TRACT B-1-B
LANDS OF GREVEY
BERNALILLO COUNTY, NEW MEXICO

AS-BUILT DRAINAGE PLAN FOR PAT'S DOORS @ 3611 SECOND ST. SW
As indicated by the as-built information shown hereon, Pat's Doors at 3611 Second Street SW has been graded and drained in substantial compliance with the approve plan with the following deviations:

PAT DOORS

AS-BUILT DRAINAGE PLAN
1"=20'

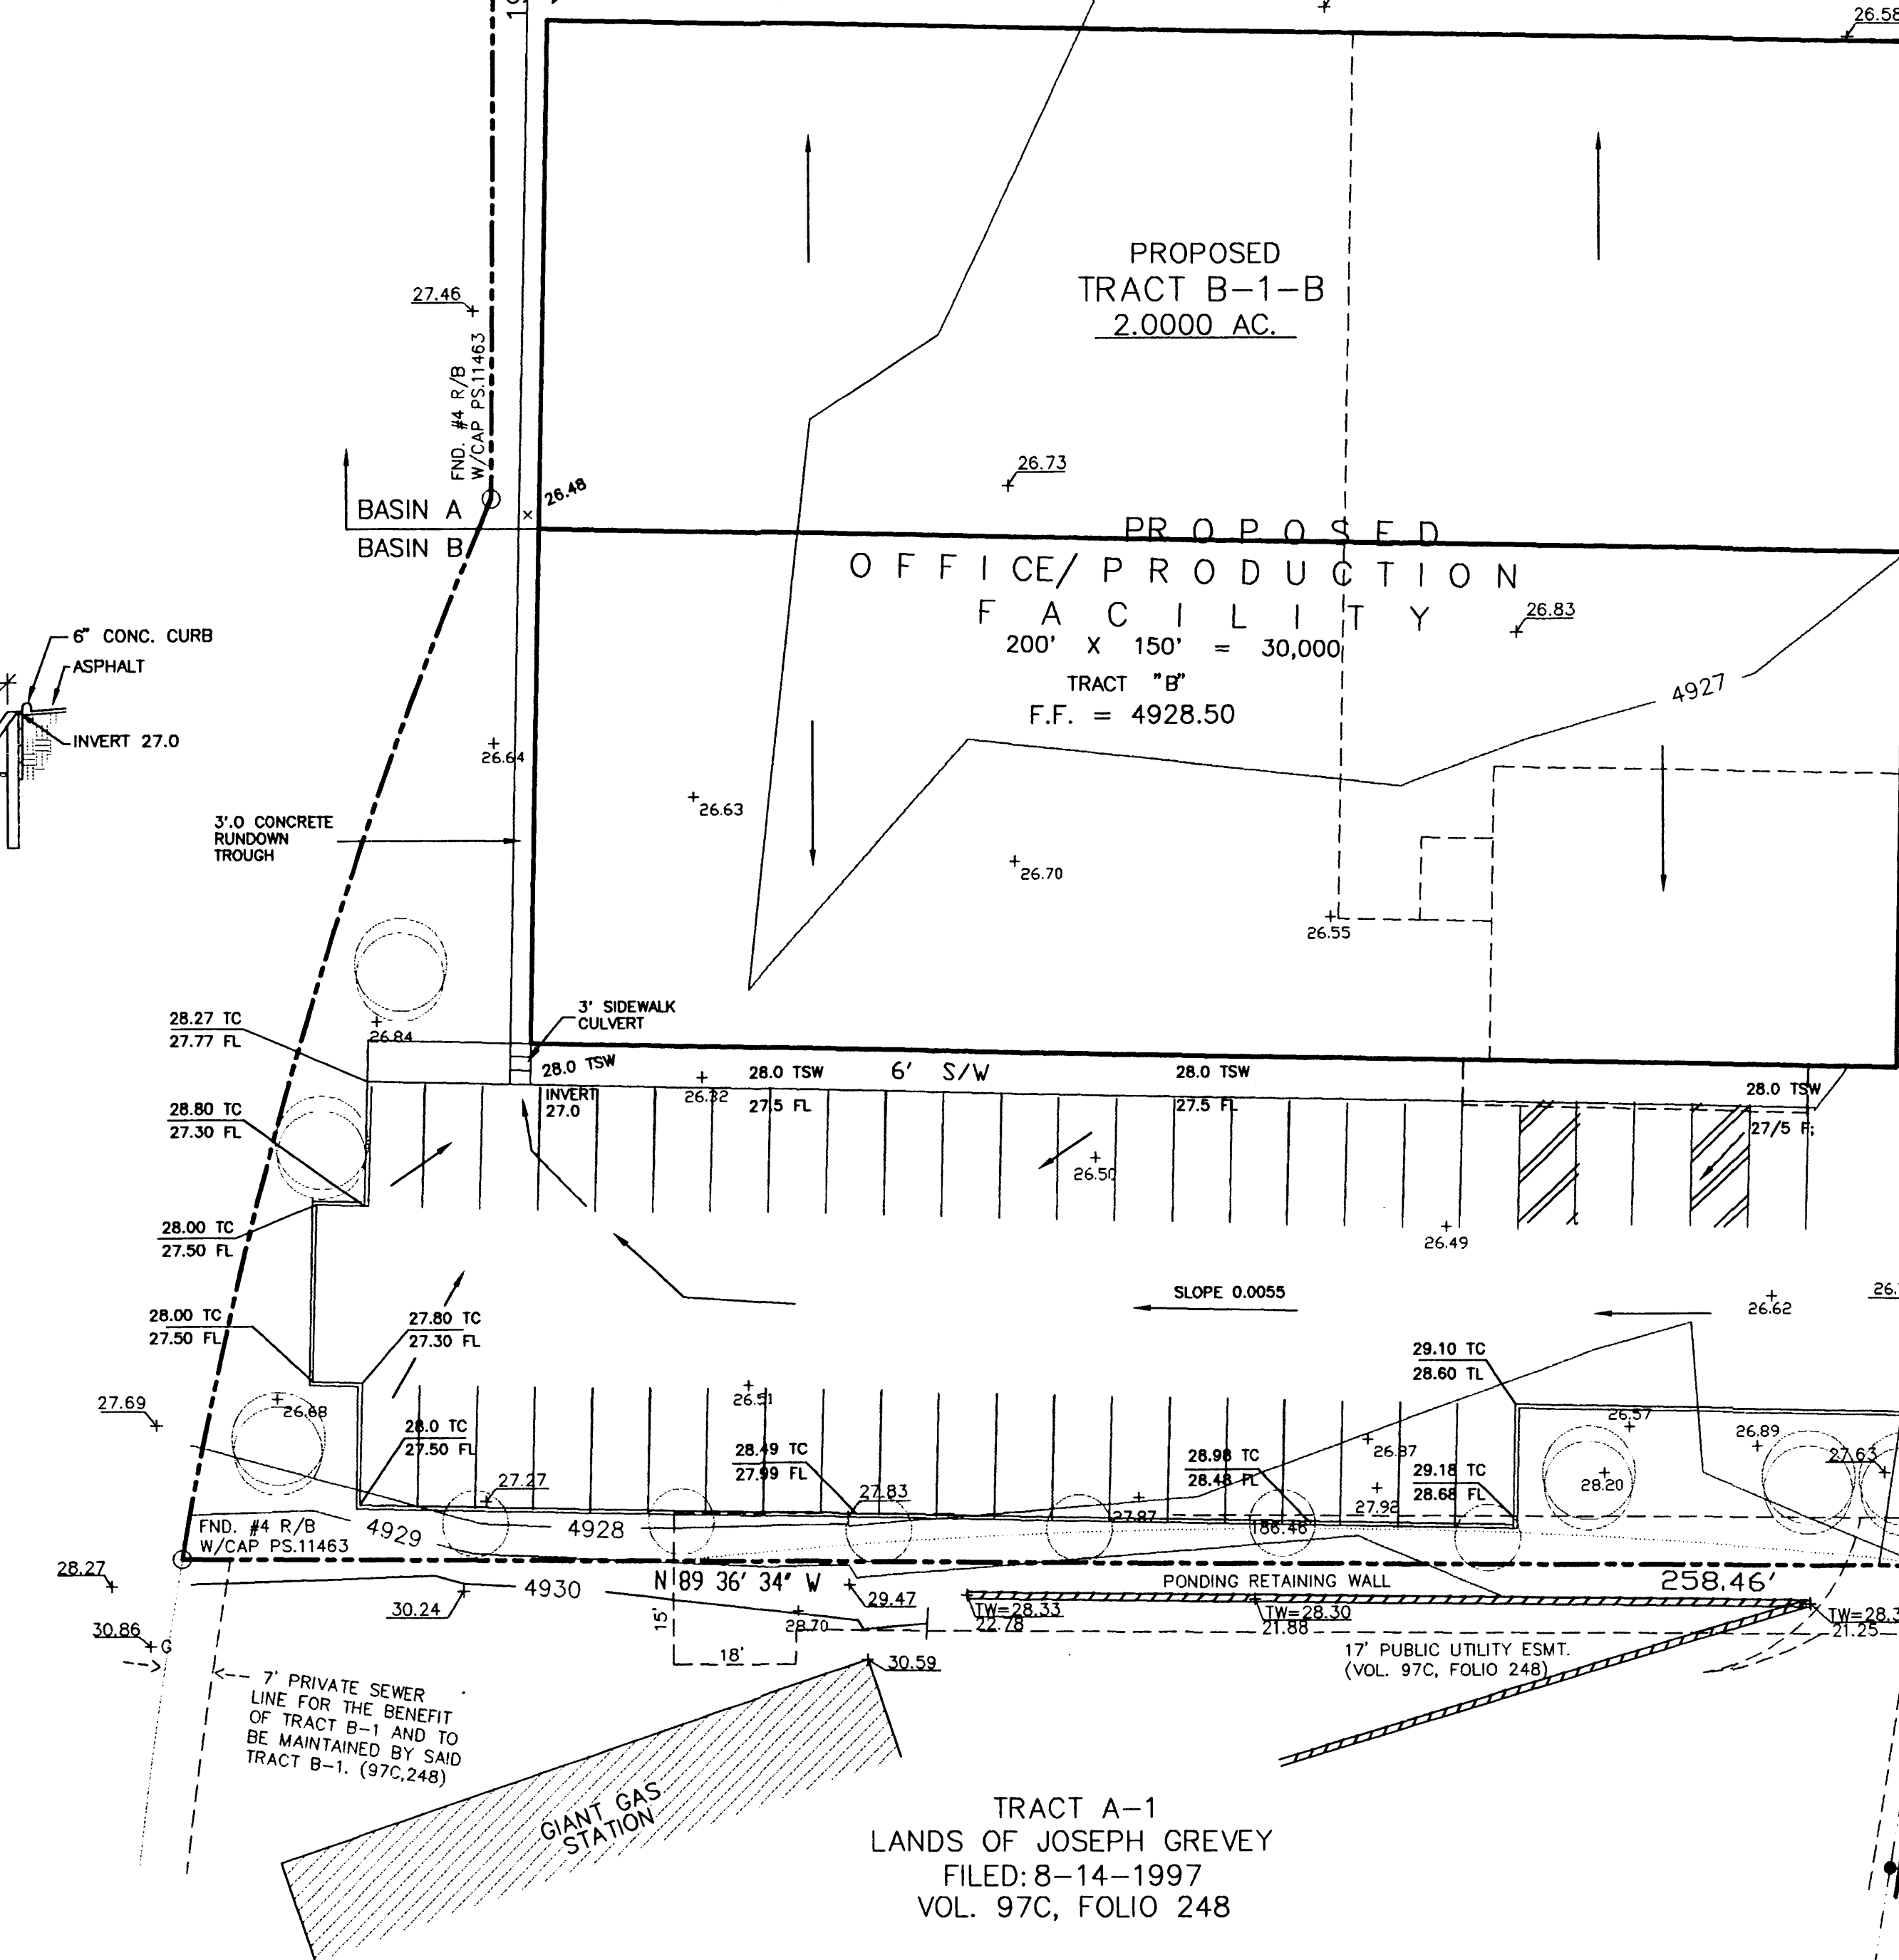
- A 3"x2" drain inlet with a 10" pvc pipe was constructed in place of the sidewalk culvert and 3' foot concrete trough.
 - The pond was over excavated to provide more capacity because of the invert of the 10" pvc pipe being lower than required.
 - Asphalt millings were placed on the north side of the building instead of asphalt paving.
- This deviations do not impact the drainage concept in any way. The site drainage will function in accordance with the pattern established by the approved plan. Therefore a permanent Certificate of Occupancy is highly recommended. The as-built information shown hereon was obtained by me or under my direct supervision and is true and correct to the best of my knowledge and belief.
